**STAFF RECOMMENDATION**

**1051 Petway Avenue**

**March 17, 2021**

**Application:** New Construction—Addition

1 ARCHITECTURAL SITE PLAN-HPR-VERSION  
1/16" = 1'-0"

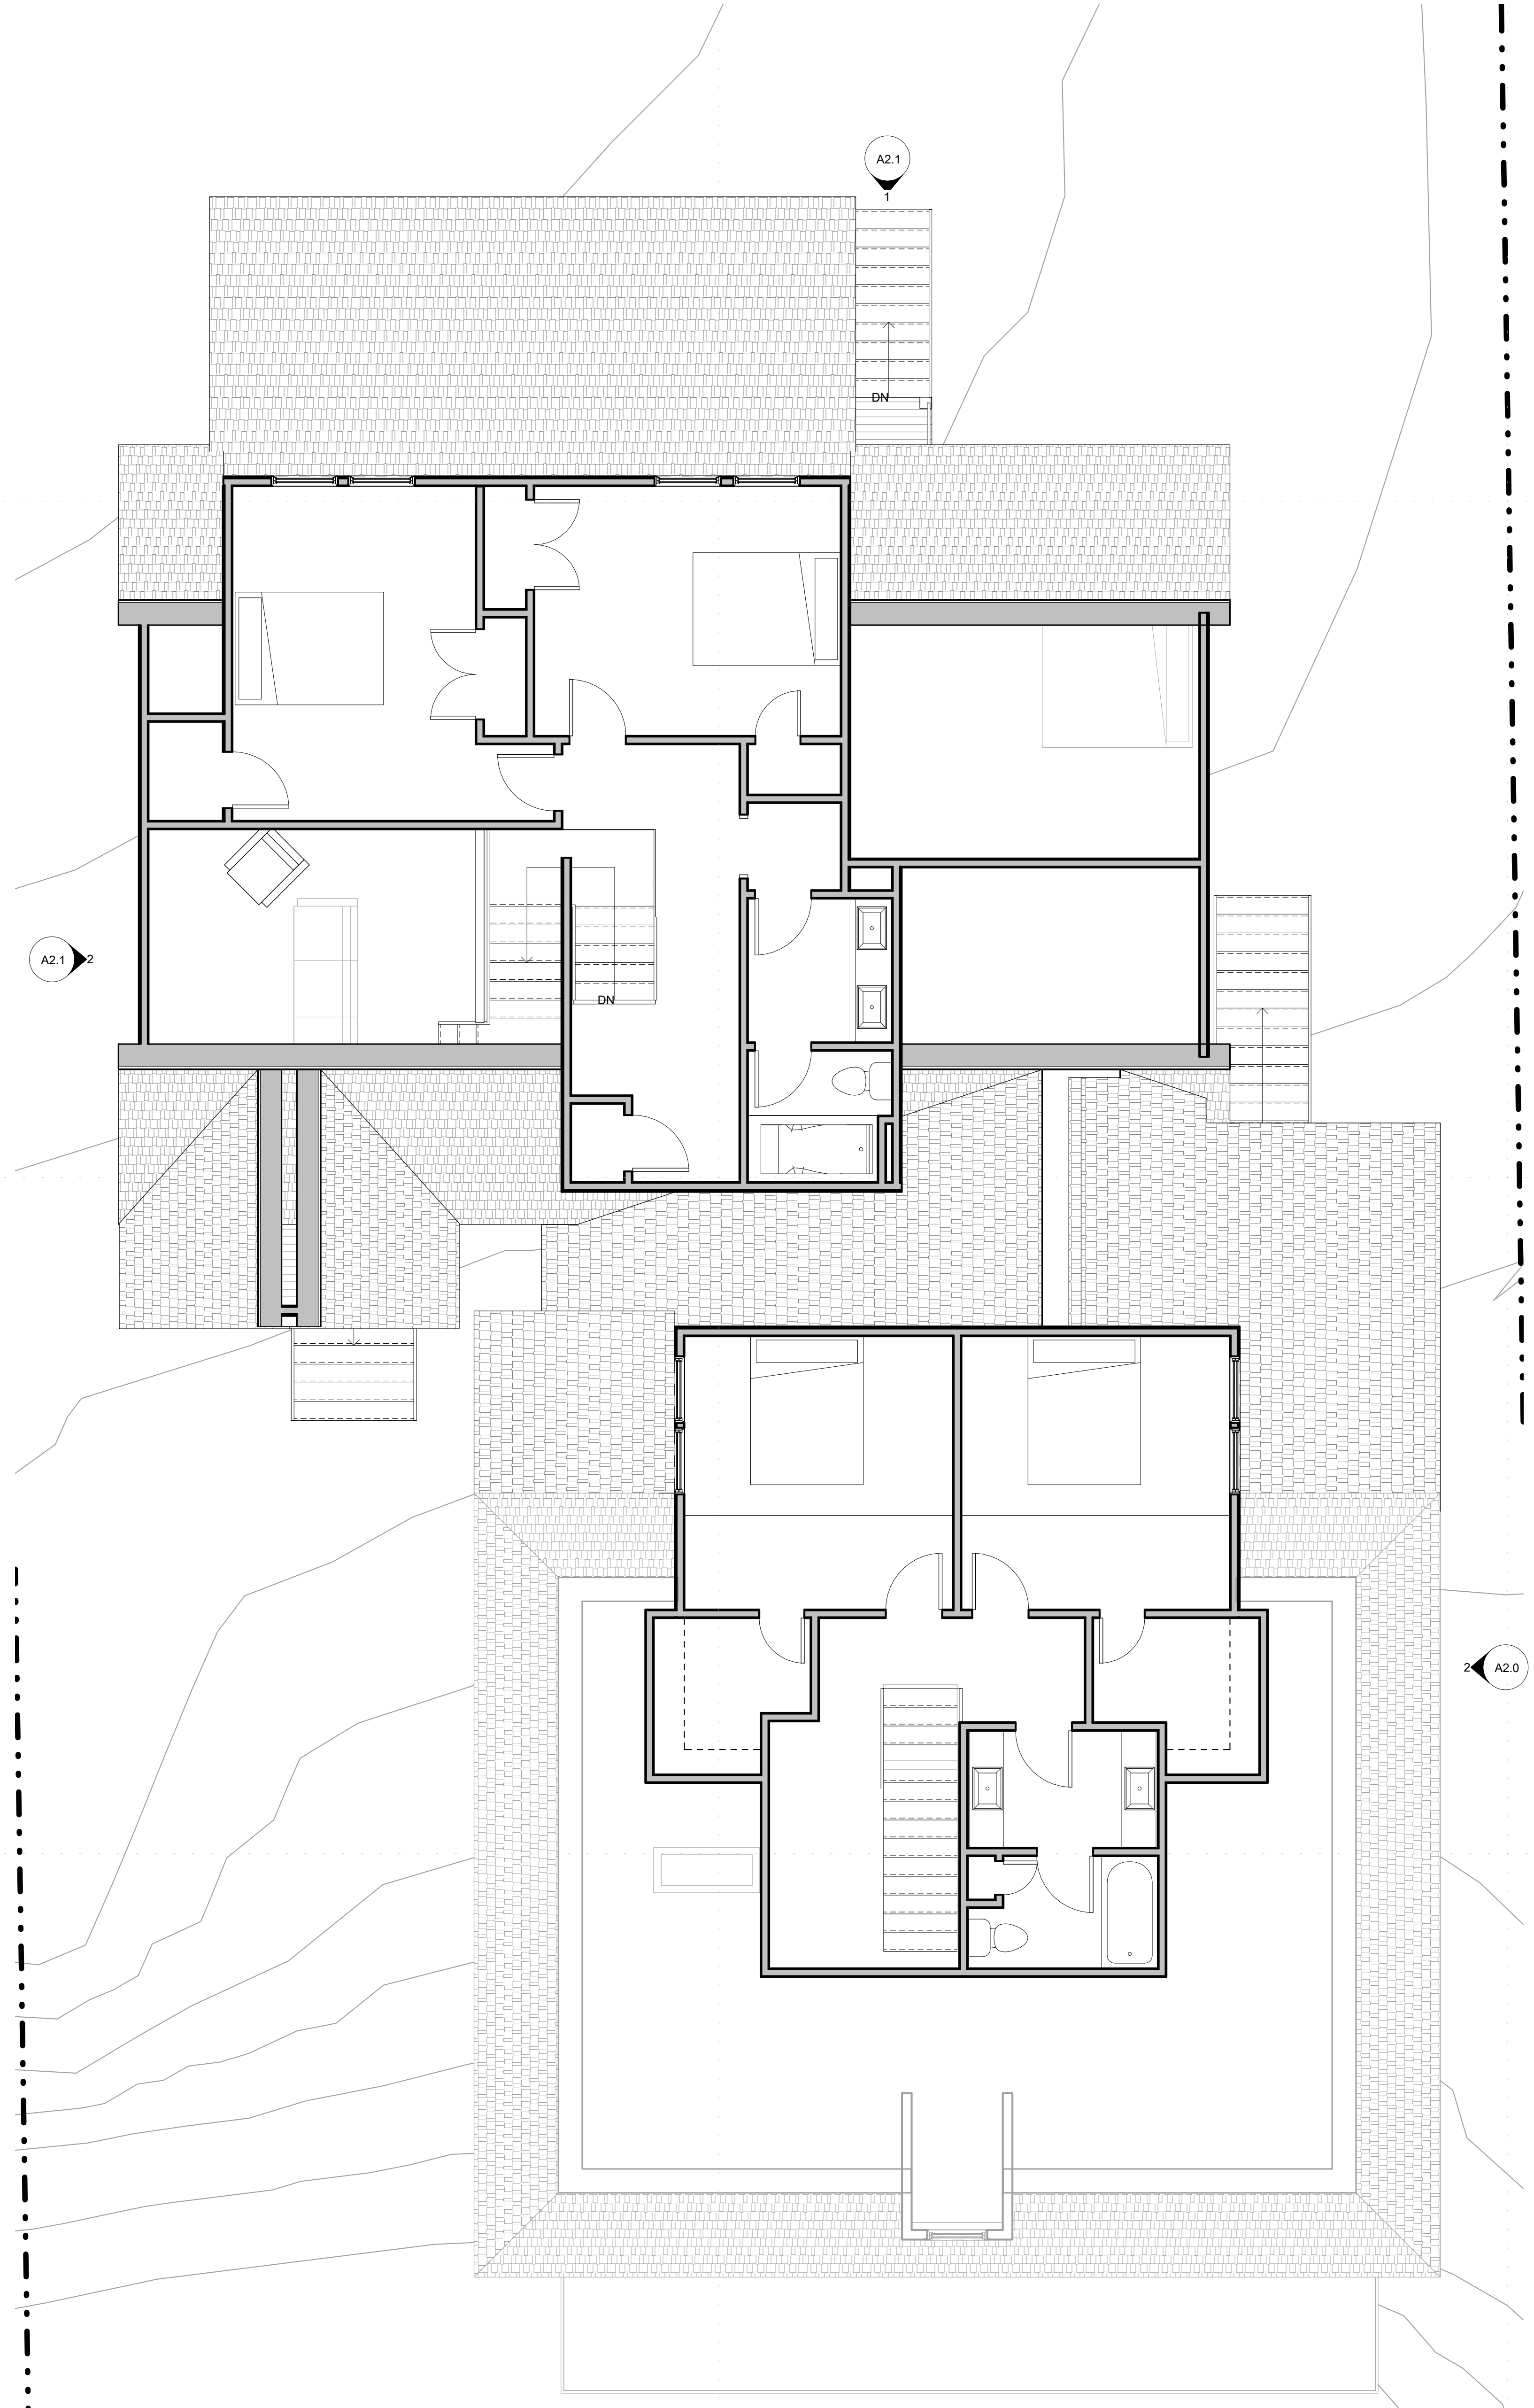
Setback & Rhythm of Spacing: The addition meets all base zoning setbacks. It will be at least five feet (5') from the right side property line, thirteen feet (13') from the left side property line, and close to one hundred and twenty feet (120') from the rear property line. The part of the addition that extends wider will not affect the rhythm of spacing of houses along Petway because it is located over forty feet (40') back from the front of the house.

Staff finds that the addition's setback and rhythm of spacing to meet Sections II.B.1.c. and II.B.2. of the design guidelines.

1 MAIN LEVEL -PROPOSED  
1/4" = 1'-0"

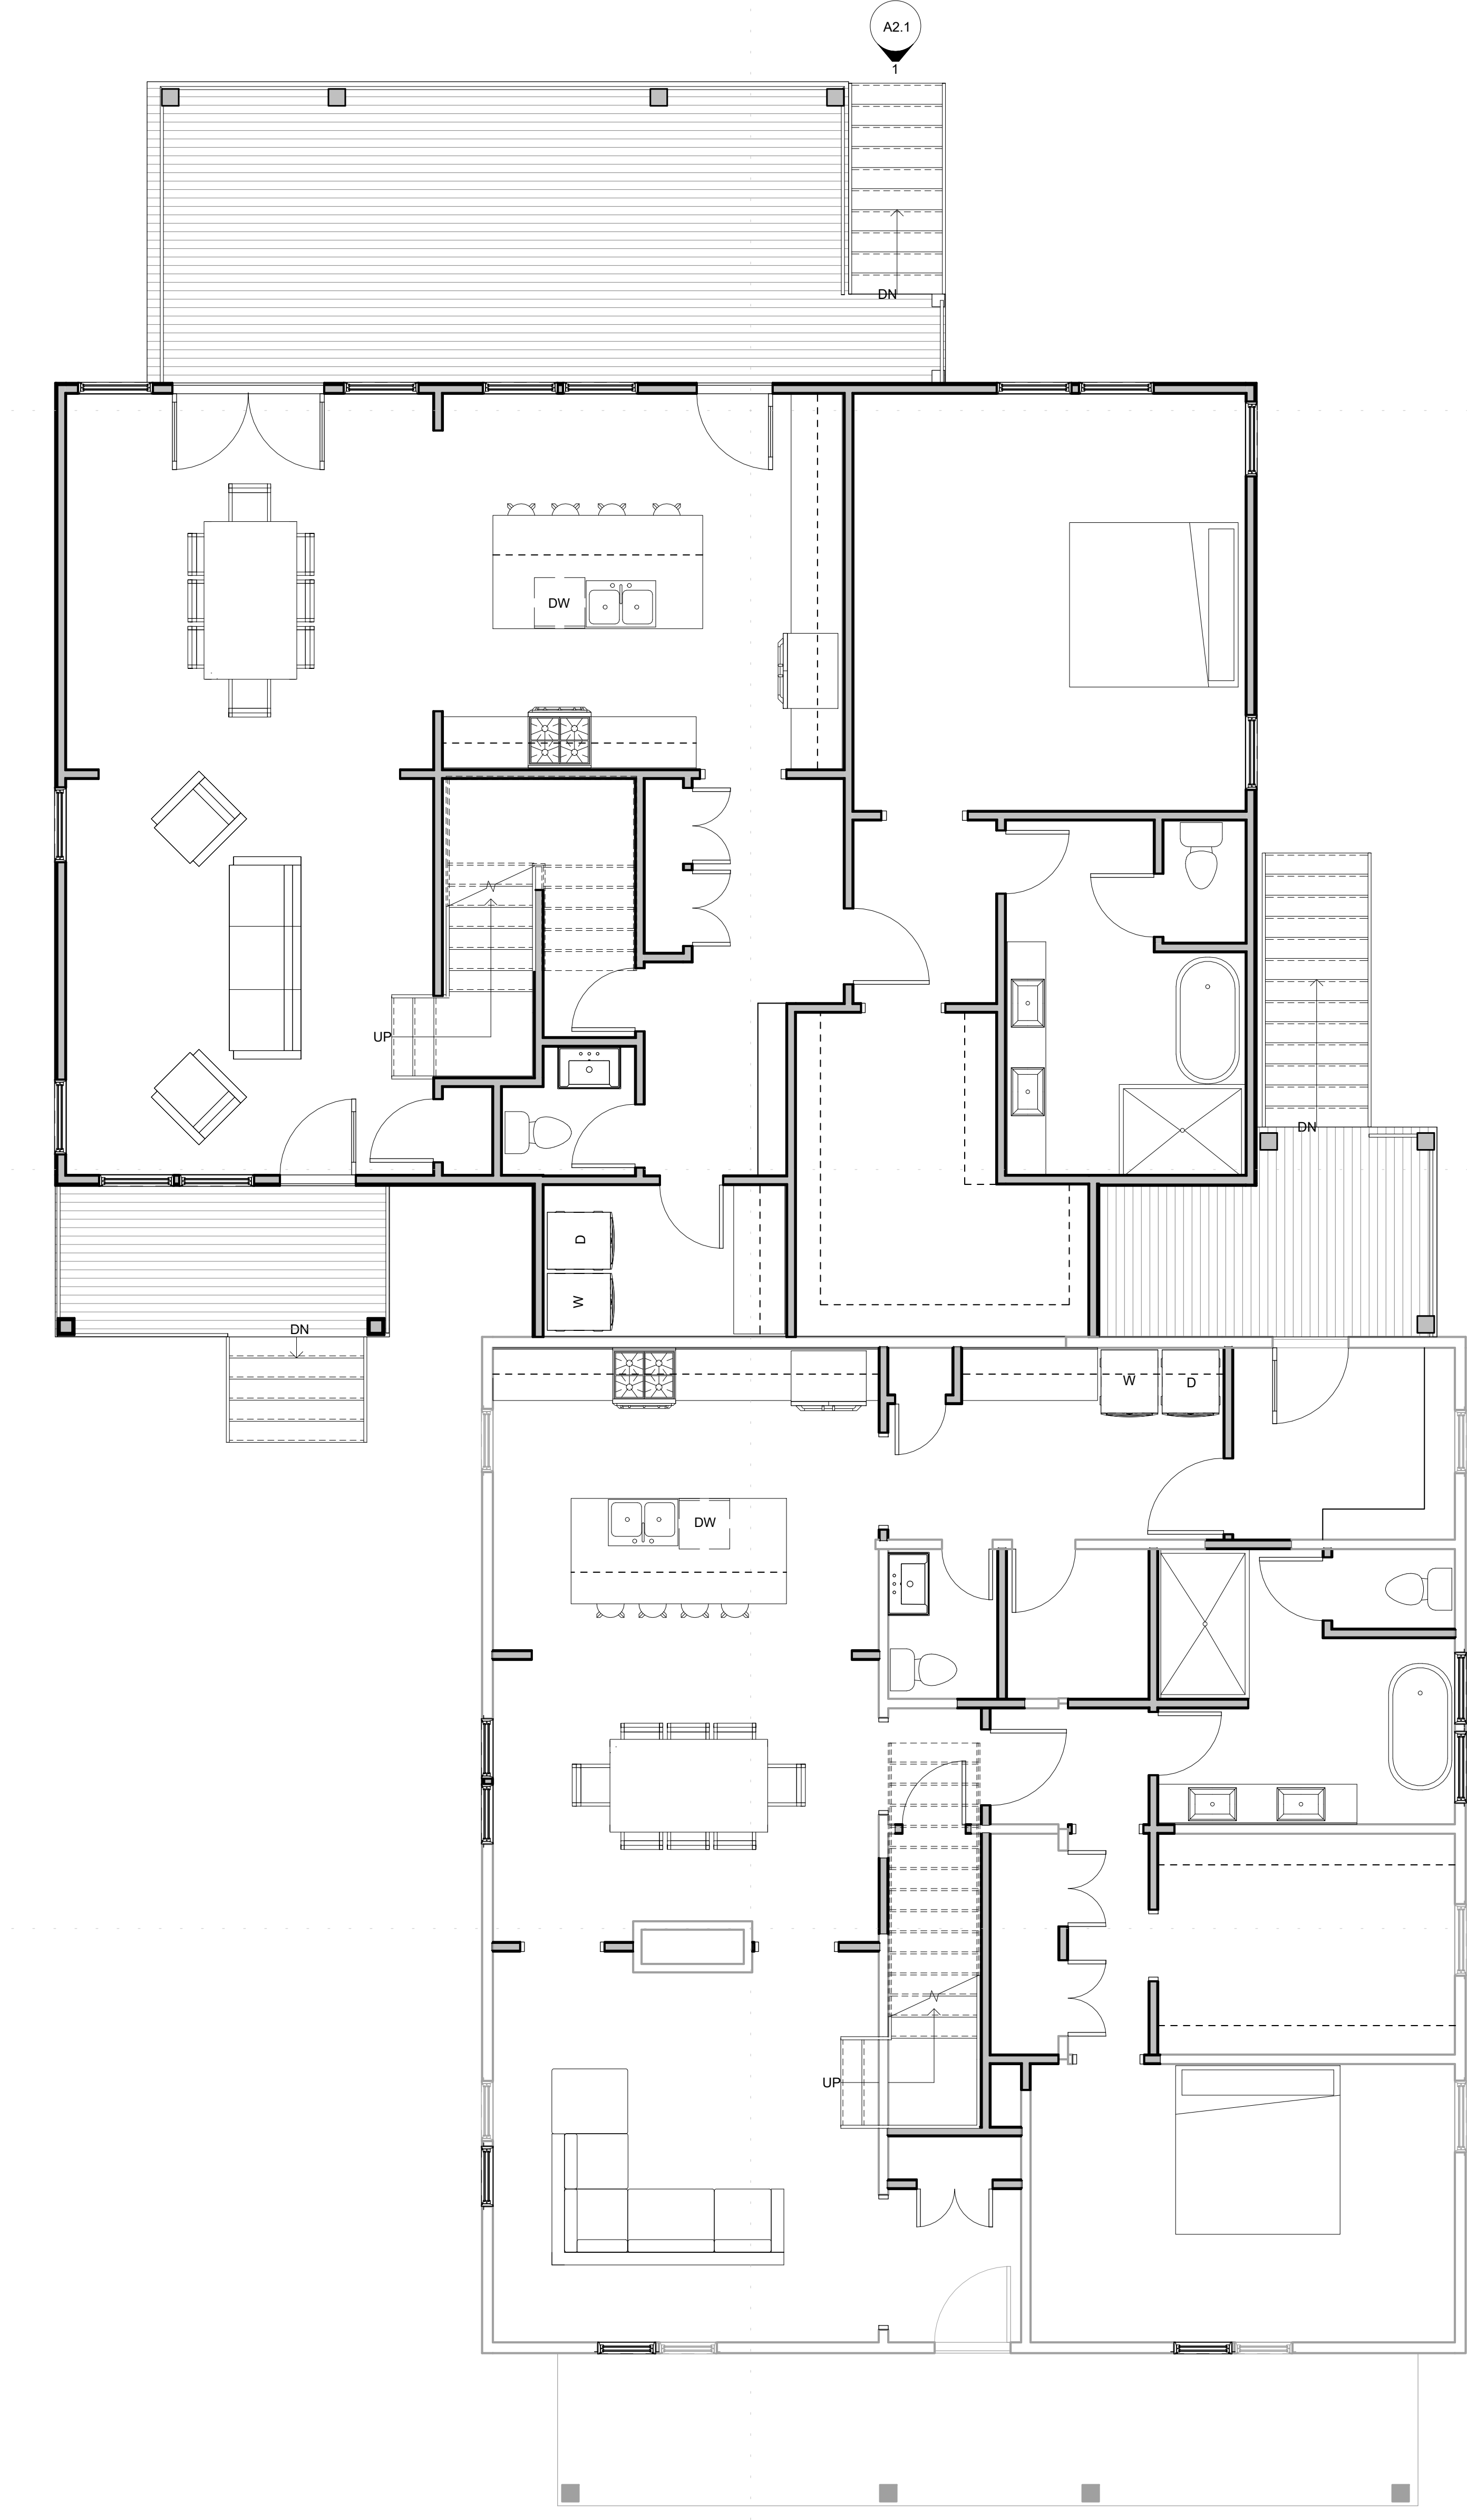
The addition is inset appropriately from both back corners. On the right side it is inset one foot (1'), which staff finds to be appropriate because this portion of the addition is a one-story porch. The second story is inset approximately seven feet (7') on the right side. On the left side, the addition is two feet (2'), but after a depth of approximately six feet

(6') the addition steps back out to be approximately seventeen feet (17') wider than the historic house. Because the lot is over sixty feet (60') wide at sixty-seven feet (67') wide, an addition that extends wider than the house to meet the design guidelines.

The addition will have a depth of fifty feet (50') and a footprint of approximately two thousand, one hundred and thirty-two square feet (2,132 sq. f.t). By comparison, the historic house has a footprint of approximately eighteen hundred square feet (1,800 sq. ft.). Although the footprint of the addition is larger than that of the historic house, staff finds it to be appropriate, in this instance, for several reasons. One, approximately three hundred and seventy-one square feet (371 sq. ft.) of the addition is a rear porch that is one story in height. Two, the addition is at least five feet (5') lower in height than the historic house, and its scale does not overwhelm the historic house. Finally, the lot is unusually large at over sixteen thousand square feet (16,000 sq. ft.). When considering the insets, lower height, and large lot size, staff finds that the footprint is appropriate to the historic house.

Staff finds that the proposed height and scale of the addition to meets Sections II.B.1.a., II.B.1.b., and II.B.2. of the design guidelines.
